**Public School and Education Employee Retirement Systems of Missouri  
First Floor Renovation**

SOA Project No. 24064

**END OF ADDENDUM NO. 2**

SCHEDULES

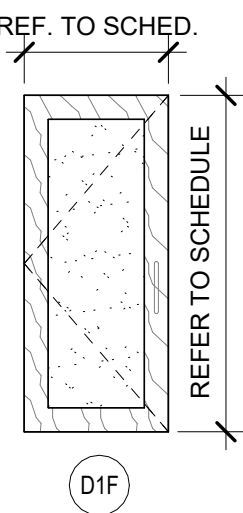
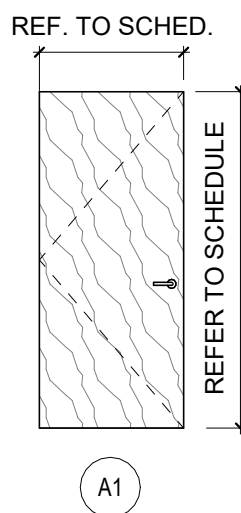
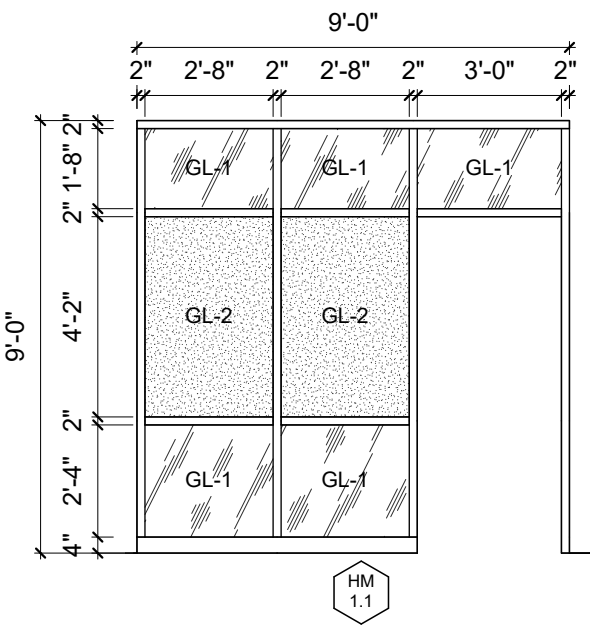
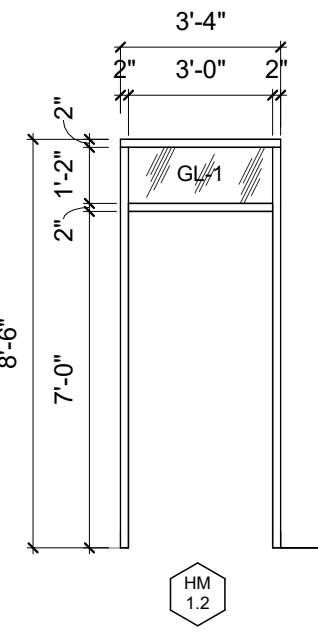
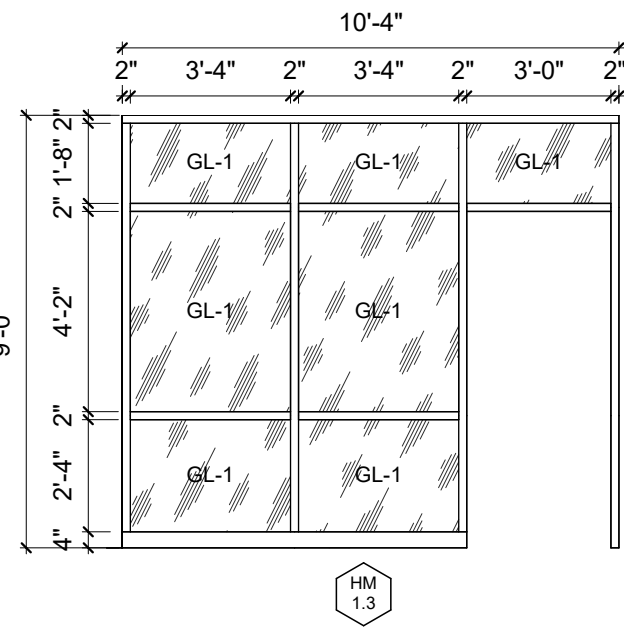
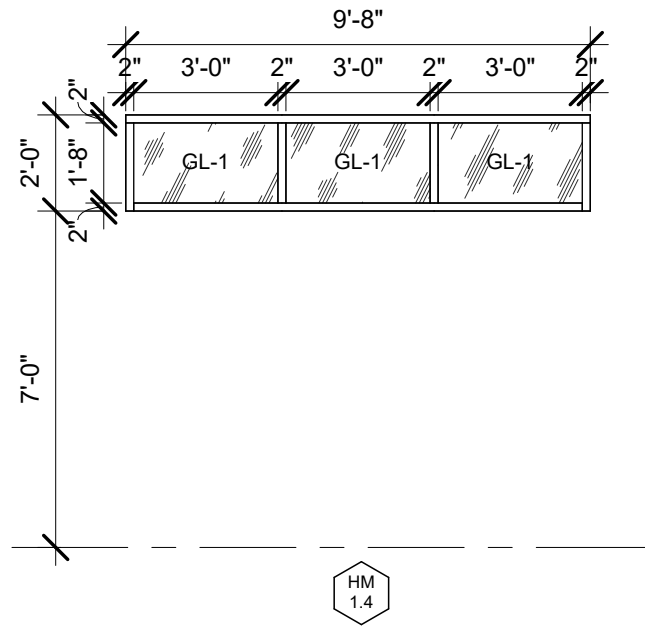
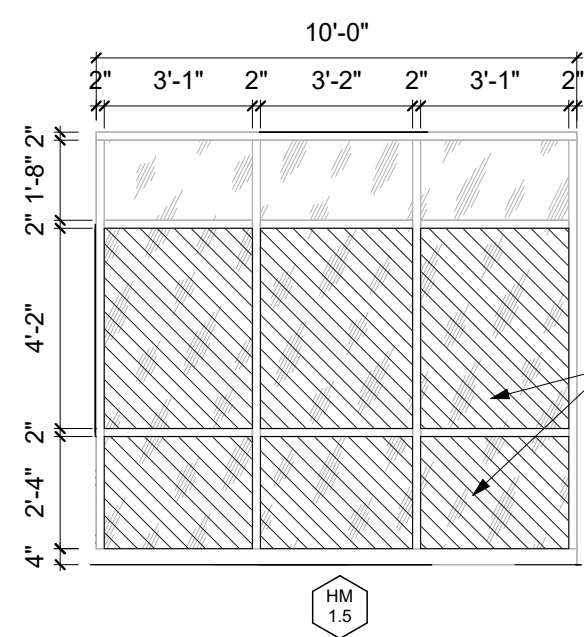
1. **A701 – SCHEDULES:**
  - a. Door and Frame Schedule:
    - i. Door 1141: OMIT the schedule note.
    - ii. Door 1143: ADD schedule Note to read as follows:

REUSE DOOR PANEL AND DOOR HARDWARE FROM SALVAGED OPENING 1143 **B**
